DRAFT FINAL to FINAL SHEET CHANGE-OUT PACKAGE

FINAL
REMOVAL ACTION COMPLETION REPORT
RADIOLOGICAL REMEDIATION AND SUPPORT
PARCEL D-1 PHASE II

HUNTERS POINT NAVAL SHIPYARD
SAN FRANCISCO, CALIFORNIA

Response to Document Review Comments			
Document Reviewed:	<i>Removal Action Completion Report Parcel D 1 Phase II Radiological Remediation and Support</i> , Hunters Point Naval Shipyard, San Francisco, California.	Date of Document:	DRAFT Aug 2017 DRAFT FINAL Jan 2017
Project Site:	Parcel D 1, Hunters Point Naval Shipyard, San Francisco, California

Exhibit 8-8. Locations where Discrete Radioactive Objects were Recovered

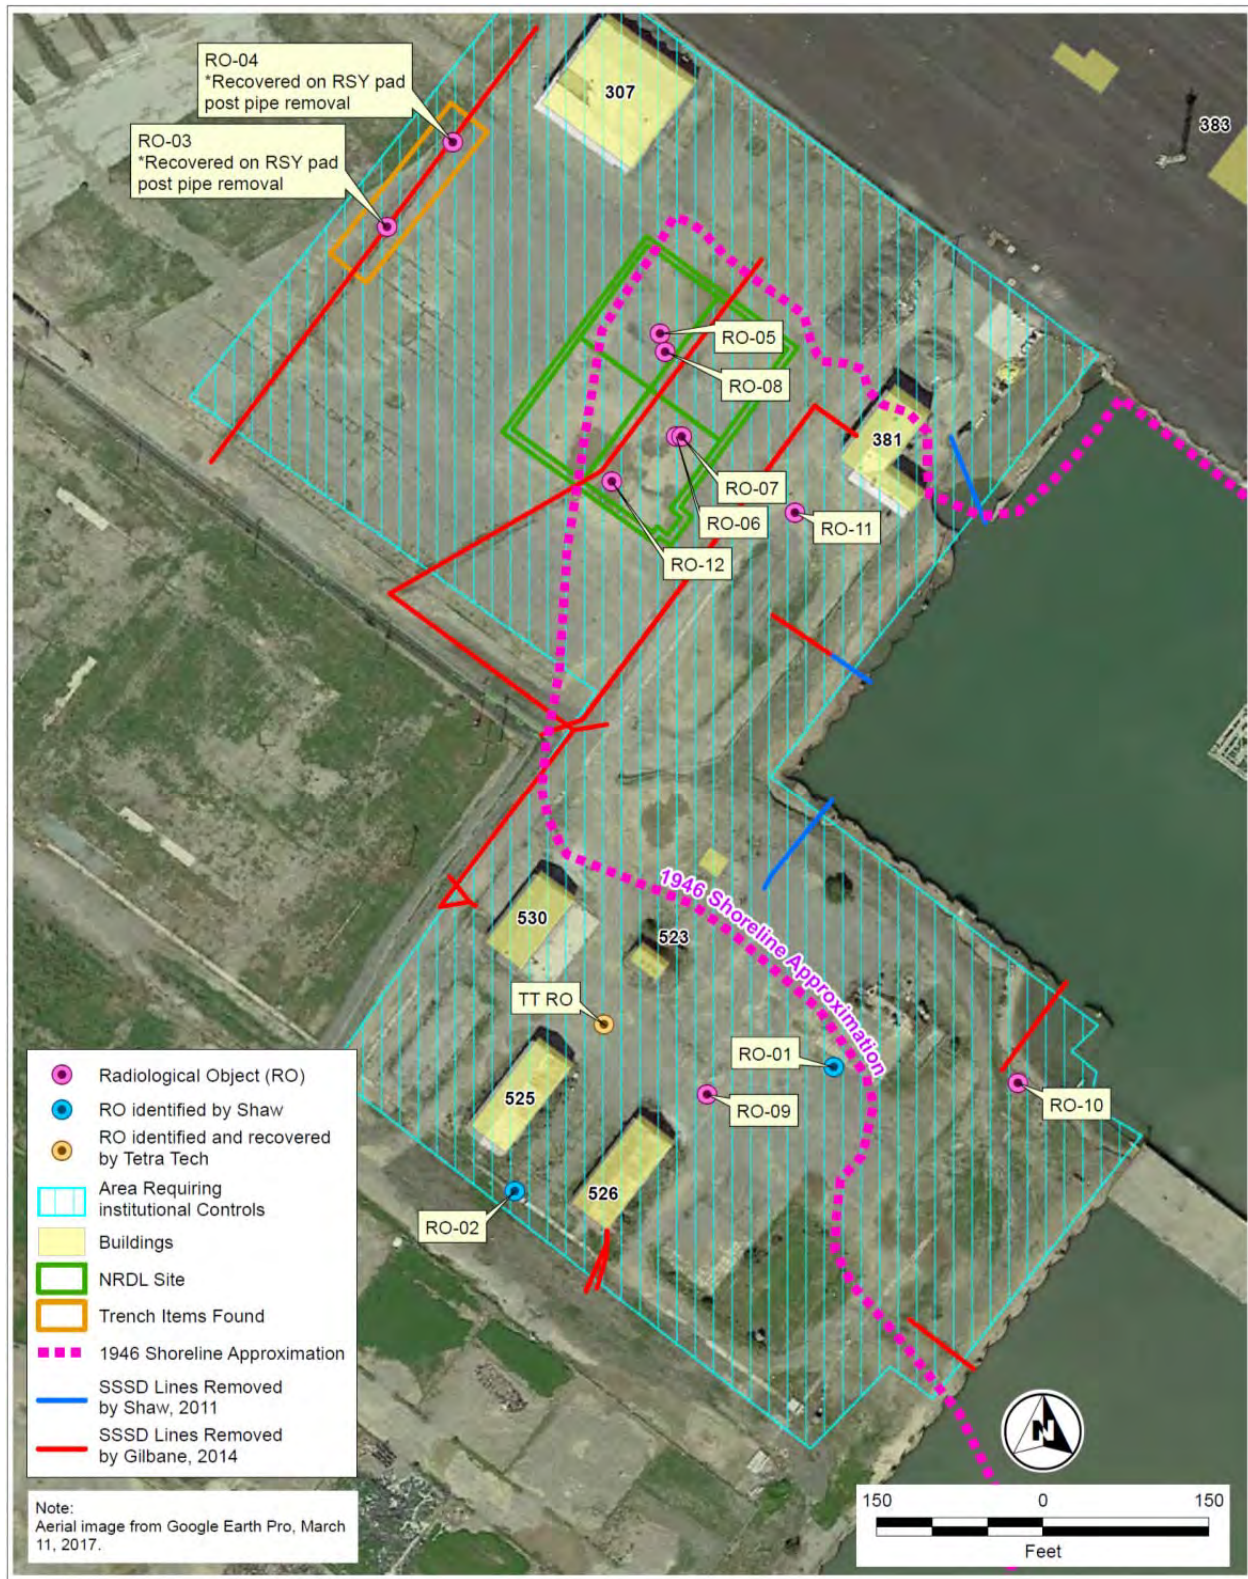
Item	Review Comment	Navy Response
		<i>radiological controls and disposing them as non LLRW."</i>
30	<p><i>(SFDPH Specific Comment #14)</i> Exhibit 8 8, Locations where Discrete Radioactive Objects were Recovered, page 52 and Section 8.3, Assessment of Results, page 53: The last paragraph states "...there is the potential for ROs to be present in material below 2 ft bgs in Parcel D 1 Phase II areas where shoreline expansion occurred in Parcel D 1 since 1946 (i.e., where dredge material from the Bay was used to create the present shoreline)." Please clearly identify this area on Exhibit 8 8 and label as "Area with Potential for Buried ROs." Was dredge material used elsewhere in Parcel D 1/other parcels inland of the 1946 shoreline? We note that Exhibit 8 8 shows ROs inland of the historic shoreline. Exhibit 8 8 needs to be revised or a new figure needs to be created to address the concerns in Comment #1.</p>	<p>Dredge spoils were used to expand the land present in 1946 to its current state in Parcel D 1. The ROs found inside of the 1946 shoreline are consistent with the conceptual site model of dredge spoils. Section 8.3 was modified to better explain and provide definition to the Navy's understanding regarding the area impacted by dredge material used to expand the land to its current state as follows: <i>"Based on the Navy's understanding of how shoreline expansion occurred, that potential [for ROs to be present in material below 2 ft bgs in Parcel D 1 Phase II areas] is largely limited to areas east of the 1946 shoreline. The likelihood of ROs outside that area is considered incidental and of low probability"</i>. Exhibit 8 8 was revised accordingly. Information on land use controls will be presented separate from the RACR.</p>

40	(CDPH Specific Comment #2) – Exhibit 8 8: It is not clear to the reader if the blue hatched area marked as, "Restriction related to radioisotopes", on Exhibit 8 8, "Locations where Discrete Radioactive Objects were Removed"; is the same area(s) as the, "buffer zone", referred to in page 57, paragraph one, sentence five. Please clarify.	The legend in Exhibit 8 8 was modified to call the cross hatching the ' <i>Area Requiring Institutional Controls.</i> ' A sentence was included in the new Section 8.3.2 that states, " <i>Therefore, a buffer zone extending beyond the 1946 shoreline approximation is included with the 2 ft bgs restriction for Parcel D 1 Phase II, which is referred to as the area requiring institutional</i>
